**RE: SSI-8862 TfNSW RMS Beaches Link EIS - Submission in Objection**

I refer to the Department of Planning, Industry and Environment (the Department) public notification to the State Significant Infrastructure (SSI) and Environmental Impact Statement (EIS) for the Transport for NSW - Roads & Maritime Services (RMS, the proponent) – Beaches Link and Gore Hill Freeway Connection project (the Project, SSI-8862).

**Figure 1 - Proponent diagram excerpt indicating a side access tunnel**

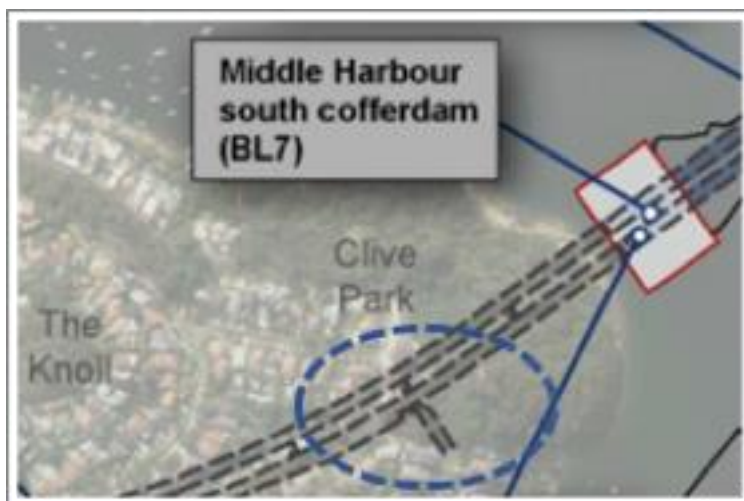
I draw attention to Clive Park's Heritage Area in Northbridge and the Proponent's proposed side access tunnel as illustrated in Figure 1 below.

The proposed works will potentially affect through above and below ground construction vibrations and ground water drawdowns the Clive Park Heritage Area (CPHA) and Aboriginal heritage elements and areas.

I strongly object to any construction phase and or permanent tunnel access being established within Clive Park at the corner of Coolawin Road and Sailors Bay Road (refer to Figure 1).

*Figure 3 Distribution of Lead contamination (extract from 'Figure 12: Distribution of Lead contamination in the Sydney Estuary'. Source: Gavin Birch, University of Sydney; Sydney Harbour Background Report, MEMA, c2014)*

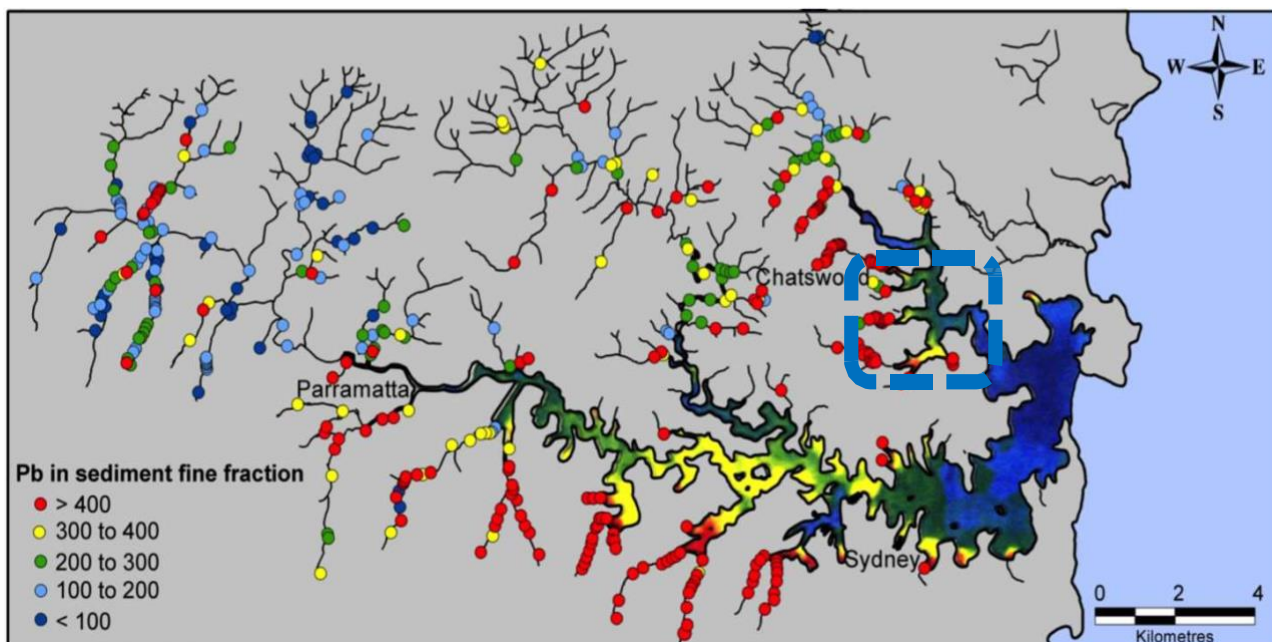
The proposed harbour crossing area is situated in a zone of 'Pb sediment fine fraction' varying between '200-400' up to greater than '>400' (refer to Figure 3) as shown below:

Figure 4 EIS Chapter 17 and Appendix P - Hydrodynamic and dredge plume modelling.

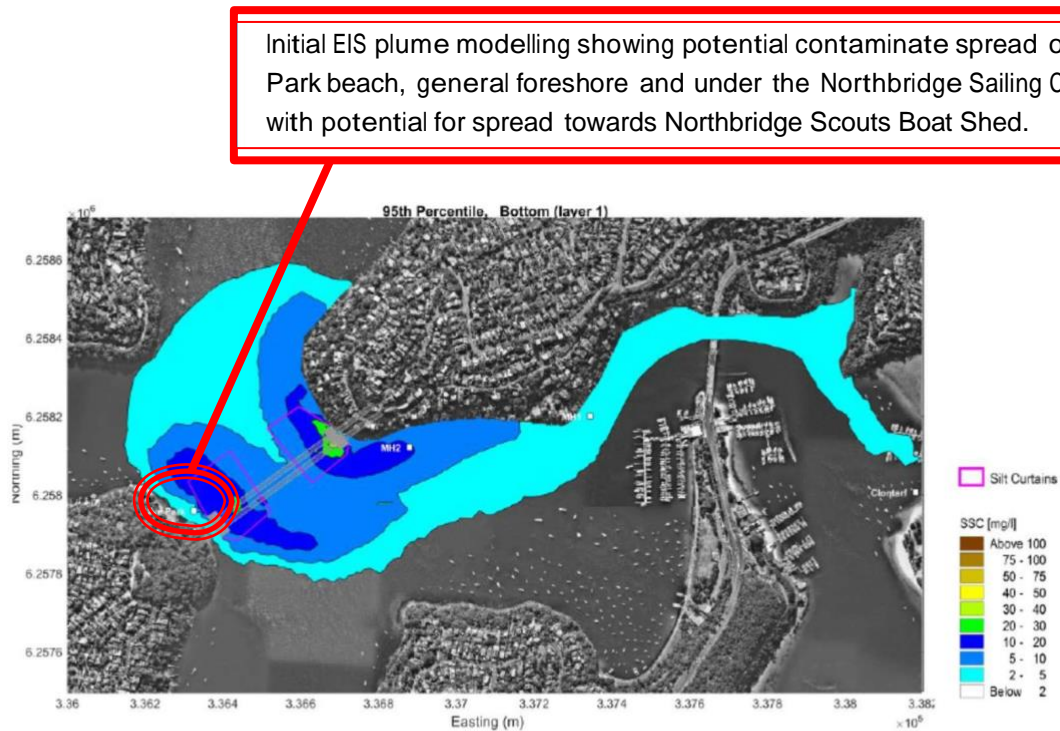
I strongly request that the 98<sup>th</sup> percentile for surface (top), mid-water column (middle) and near the seabed (bottom) for the BHD only dredging period (weeks 1 to 4) be released to the Department by the Proponent. This will ensure in the Public's mind that fulsome and transparent assessment pertaining to other community and public assets are taken into consideration. I have deep concerns that Northbridge Baths and 1<sup>st</sup> Sailors Bay Boat Shed could be potentially affected, and the release of this additional dredge plume modelling would potentially allay concerns and permit public scrutiny.

Figure 5 EIS Chapter 17 and Appendix P - Hydrodynamic and dredge plume modelling

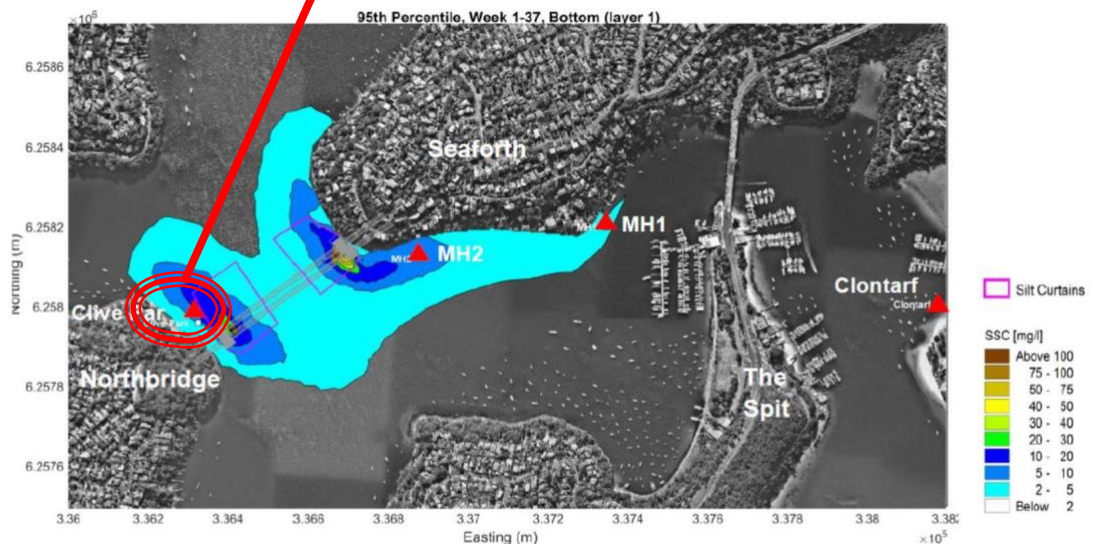
Initial EIS plume modelling showing potential contaminate spread over Clive Park beach, general foreshore and under the Northbridge Sailing Club land and potential for spread under Northbridge Sea Scout Boat Shed.

I strongly request that the 98<sup>th</sup> percentile for surface (top), mid-water column (middle) and near the seabed (bottom) for the entire dredging period (weeks 1 to 37) be released to the Department by the Proponent. This will ensure in the Public's mind that fulsome and transparent assessment pertaining to other community and public assets are taken into consideration. I have deep concerns that Northbridge Baths and 1<sup>st</sup> Sailors Bay Boat Shed could be potentially affected, and the release of this additional dredge plume modelling would potentially allay concerns and permit public scrutiny.

*Figure 7 App G Noise and Vibration – BL7 (Standard Hours), LAeq (15min) at 70-75dB(A) at the Northbridge Sailing and Northbridge Scout Boat Shed (Red)*

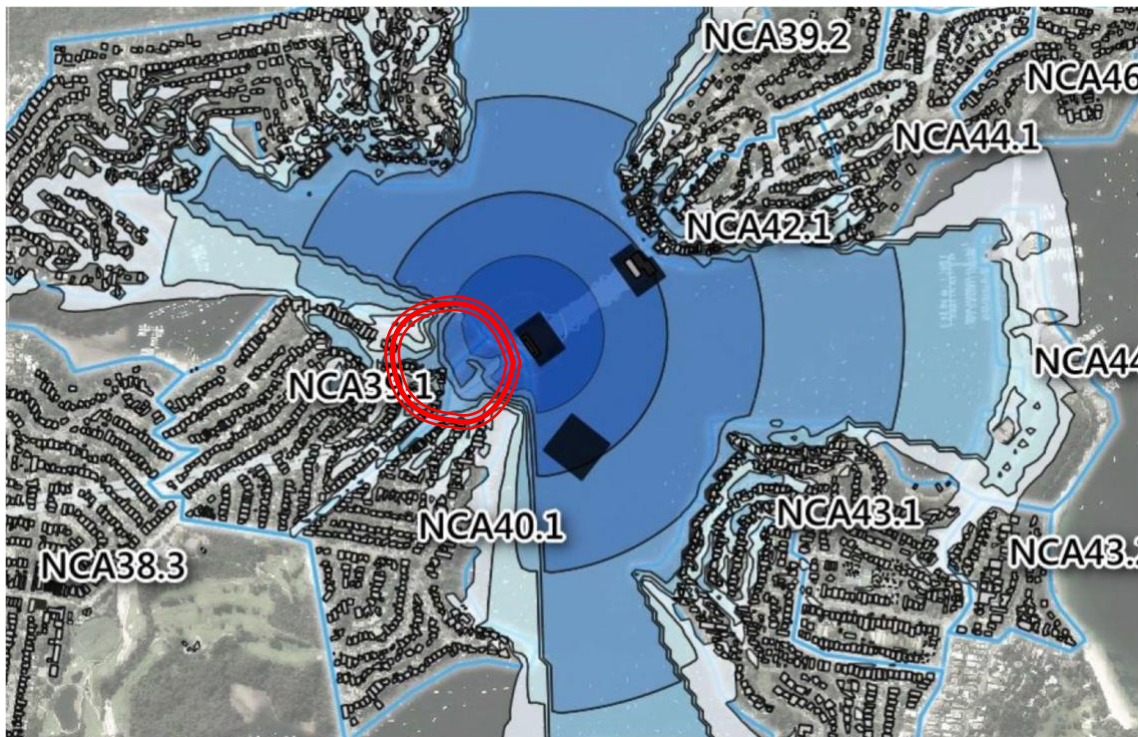
Numerous residents in Northbridge and Seaforth, the Northbridge Sailing Club and Northbridge Scouts Boat Shed areas will be subjected to prolonged periods of construction noise between 70-75dB(A) as shown in Figure 7.

This level of noise exposure is considered a ‘Highly Noisy’ environment (refer to Figure 8) and prolonged periods of exposure to this high level of noise can and will be damaging<sup>3</sup> to the local residents and to the public using Clive Park, recreational activities associated with the Northbridge Sailing Club and Northbridge Sea Scouts.

**Figure 11 Beaches Link interactive portal overlaid with the Clive Park shelter/cave location (green)**

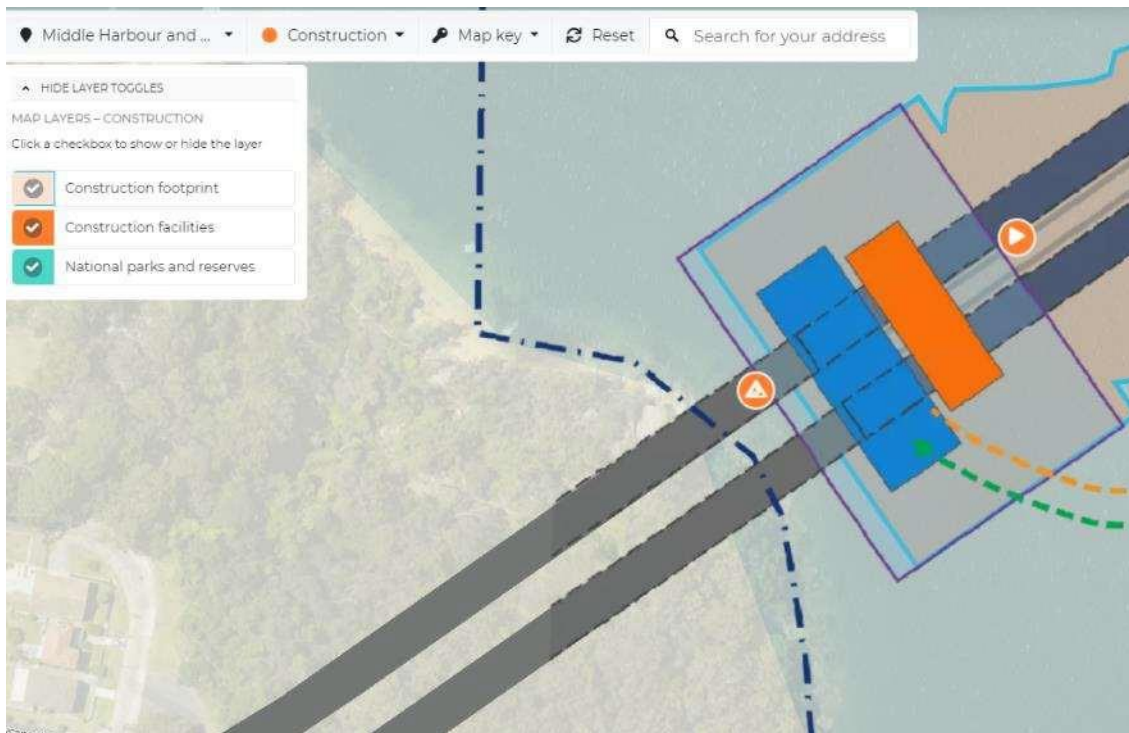
The north bound tunnel and associated rock bolting used with this type of construction, and based on the EIS tunnel and coffer dam sections/sketches (which are not detailed nor definitive), the rock bolts will probably be located within 10-15 metres and the tunnel crown at 15-20 metres to the bottom of the rock outcrop.

Therefore, there is a high potential of Aboriginal shelter/cave subsidence, high potential for significant damage to irreplaceable Aboriginal artworks (which are immediately adjacent to the shelter/cave) or in the worst case full rock face collapse and the risk/hazard to the public who frequent this park area, due to the Proponents tunnelling and coffer dam works (refer to Figure 11 and Figure 12).
